DART SERVICE INSTRUCTION

TO AMEND INSTALLATION INSTRUCTIONS IIN-D350-689 REV. D OR LATER AND FLIGHT MANUAL SUPPLEMENT FMS-D350-689 REV. B OR LATER AND INSTRUCTIONS FOR CONTINUED AIRWORTHINESS ICA-D350-689 REV. 4 OR LATER

REF. CANADIAN STC: SH02-33 REF. FAA STC: SR01620NY REF EASA STC: EASA.IM.R.S.01453

FIGURE 1: D350-689-021 INSTALLATION (FOR 159000-26 SEAT TRACKS)

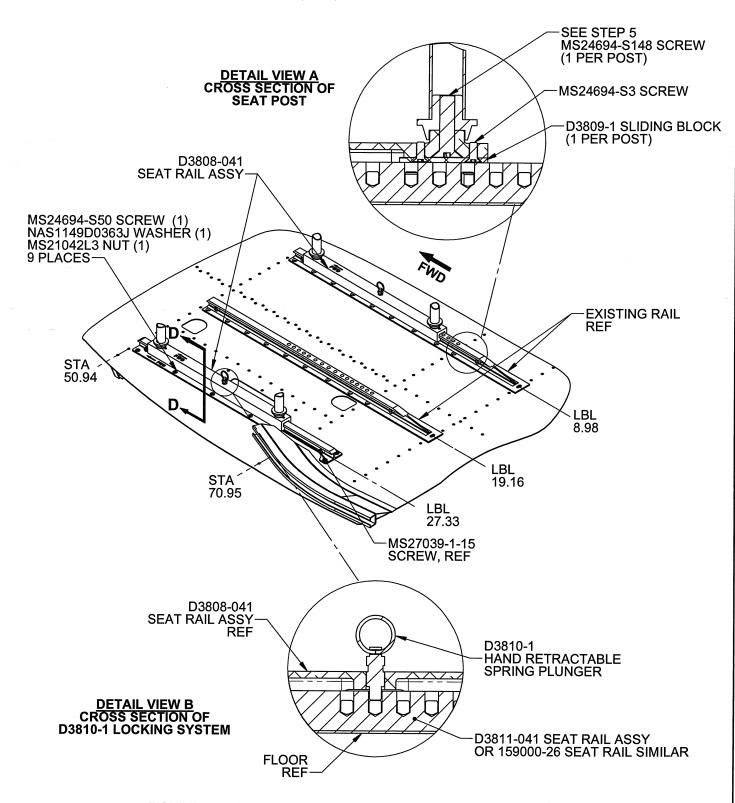
- 1. Install the under floor structure as outlined in Section 3.10 of IIN-D350-689 Rev. D.
- 2. For aircraft equipped with p/n 159000-26 Seat Tracks, position the D3811-041 Seat Track Assy at LBL 27.33 as shown in Figure 1 to be in-line with the existing seat rails at LBL 8.98 and LBL 19.16.

- 4. Transfer the attachment holes from D3811-041/-043 Seat Track Assy to aircraft floor (9/12 pls) using a \emptyset 0.201 (#7 drill). Deburr holes. Install D3811-041/-043 using (9/12) MS24694-S50 screws, (9/12) NAS1149D0363J washers, and (9/12) MS21042L3 nuts as shown in Figure 1. Torque screws to 20 to 25 in-lbs (2.3 to 2.8 Nm).

- 5. If converting a -041 Seat Assembly to a -043 Seat Assembly, remove D3028-1 Studs, D3029-1 Springs, and D3030-1 Locks from the D350-689-041 Seat Assembly. Install (2) D3808-041 Seat Rails Assemblies as shown in Figure 1 Detail A using (4) MS24694-S148 Screws. Torque screws to 100 to 140 in-lbs (11.3 to 15.8 Nm). Install D3809-1 Sliding Blocks using (2) MS24694-S3 screws as shown in Figure 1 Detail A. Torque screws to 12 to 15 in-lbs (1.4 to 1.7 Nm).

FIGURE 2: D350-689-021 INSTALLATION (FOR F0425031 SEAT TRACKS)

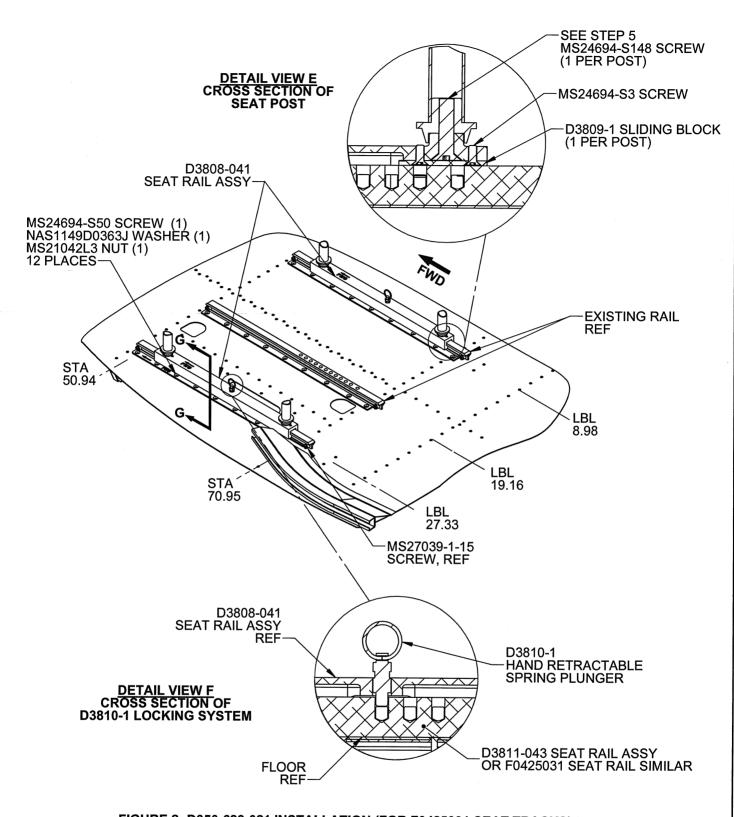
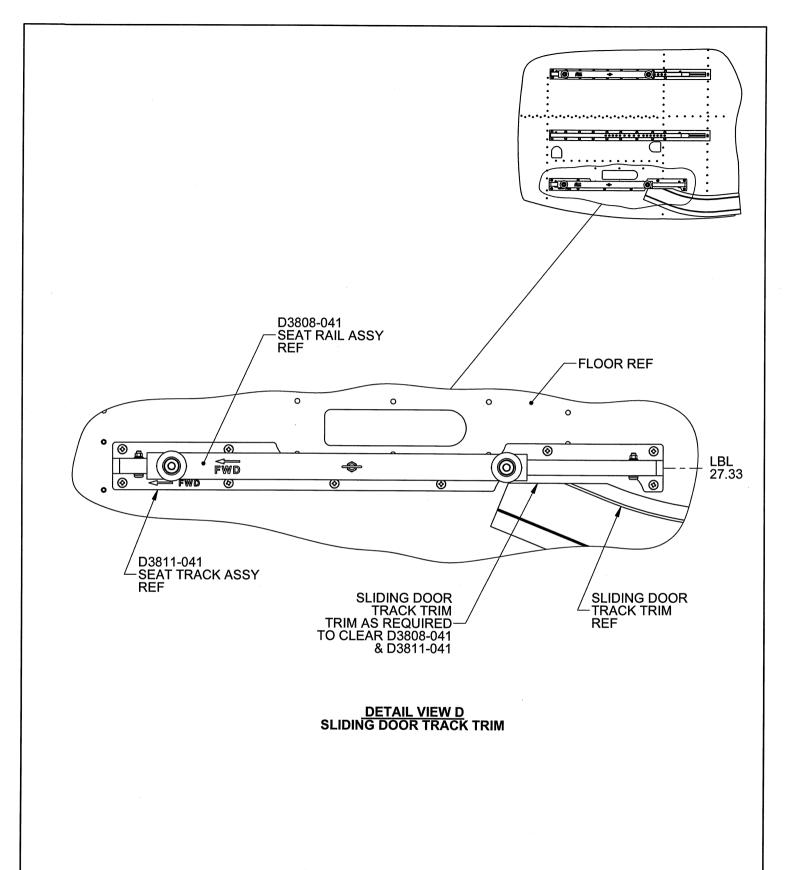
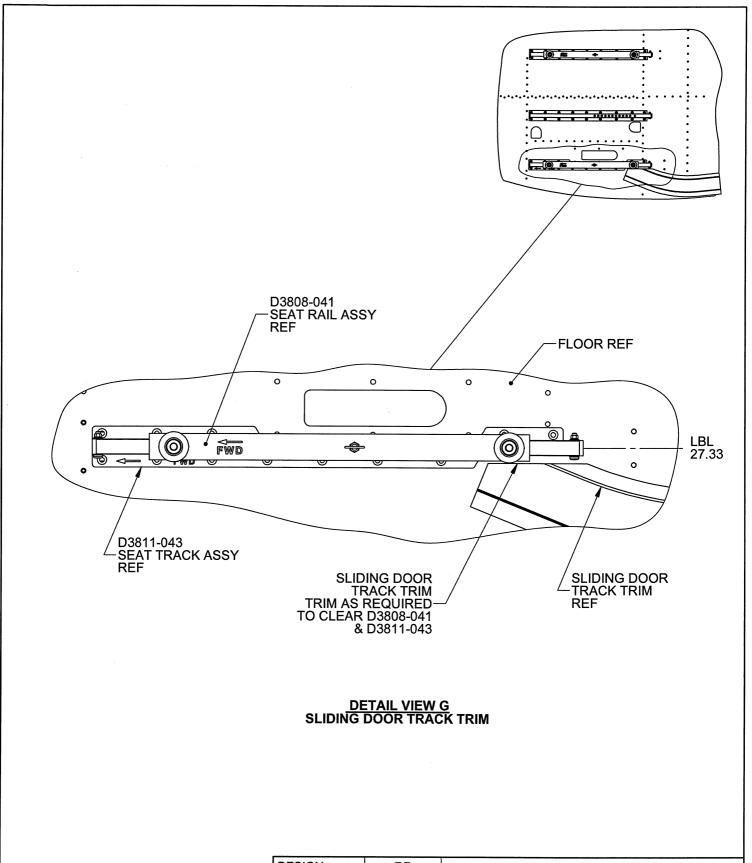
- 3. For aircraft equipped with p/n F0425031 Seat Tracks, position the D3811-043 Seat Track Assy at LBL 27.33 as shown in Figure 2 to be in-line with the existing seat rails at LBL 8.98 and LBL 19.16.
